Access Compliance Report Public Rights-of-Way (Curb Ramps)

Main Street: AMARYLLIS_ST Cross Street: SKLAR_ST Location: NW

ADA ID: RPAT211102105403 Ramp Type: Type 4 - Parallel Initial Pass/Fail: Pass Overall Compliance: No Severity Score: 15

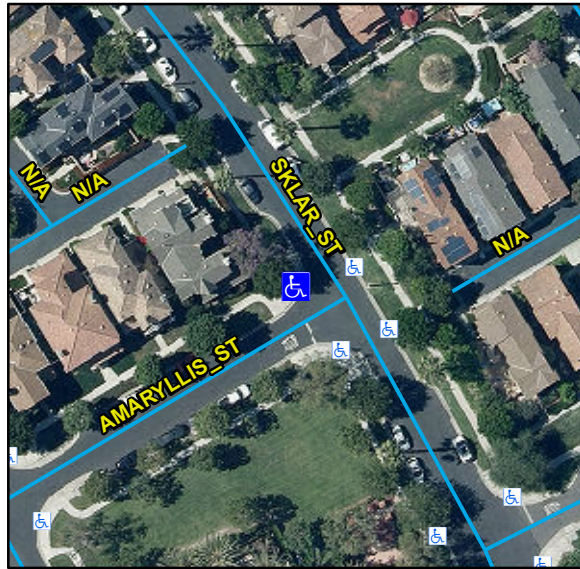
Compliance	Description	Data	Compliance	Description	Data
N/A	Ramp Length LT (in)	110	N/A	Ramp Length RT (in)	95
Yes	Ramp Width LT (in)	88	Yes	Ramp Width RT (in)	88
Yes	Ramp Run Slope LT (%)	3.7	Yes	Ramp Run Slope RT (%)	4.8
Yes	Ramp Cross Slope LT (%)	1.3	Yes	Ramp Cross Slope RT (%)	1.4
N/A	Landing Present	Yes	No	DWS Provided	No
N/A	Landing Length (in)	88	N/A	DWS Contrast	N/A
Yes	Landing Width (in)	48	N/A	DWS Length (in)	N/A
Yes	Landing Run Slope (%)	1.3	N/A	DWS Full Width	N/A
Yes	Landing Cross Slope (%)	1		DWS Offset Type	N/A
N/A	Landing Movement Obstructed?	No	N/A	DWS Offset Left (in)	N/A
	Landing Movement Type	Curb	N/A	DWS Offset Right (in)	N/A
N/A	Landing Shared	No			
N/A	Clear Space	Yes			
N/A	Clear Space To Crosswalk (in)	48			
N/A	Marked Crosswalk 1	No	N/A	Marked Crosswalk 2	No
	Crossing 1 Direction	S		Crossing 2 Direction	E
N/A	Marked Crosswalk 1 Width (in)	N/A		Marked Crosswalk 2 Width (in)	N/A
N/A	Ramp Inside Crosswalk 1	N/A	N/A	Ramp Inside Crosswalk 2	N/A

Crossing 1 Slope (%)	3.3		Crossing 2 Slope (%)	1.8
	Crossing 1 Cross Slope (%)	1.1		Crossing 2 Cross Slope (%)	1.4
Yes	Gutter Ponding	No	No	Curb Slope	13.5
Yes	Gutter Lip Height (in)	0		Road Run Slope (%)	0.2
No	Gutter Run Slope (%)	5.5		Road Cross Slope (%)	2
Yes	Gutter Cross Slope (%)	0.3	No	Perpendicular Joint Present	No
Yes	Overall Surface Condition	Acceptable			
	Cross Gutter Present?	No		Spandrel Present?	No
	Replace Cross Gutter?	N/A		Replace Spandrel?	N/A

Remove & Replace Curb Ramp With Two New Directional Ramps or Equivalent. Remove & Replace Gutter.
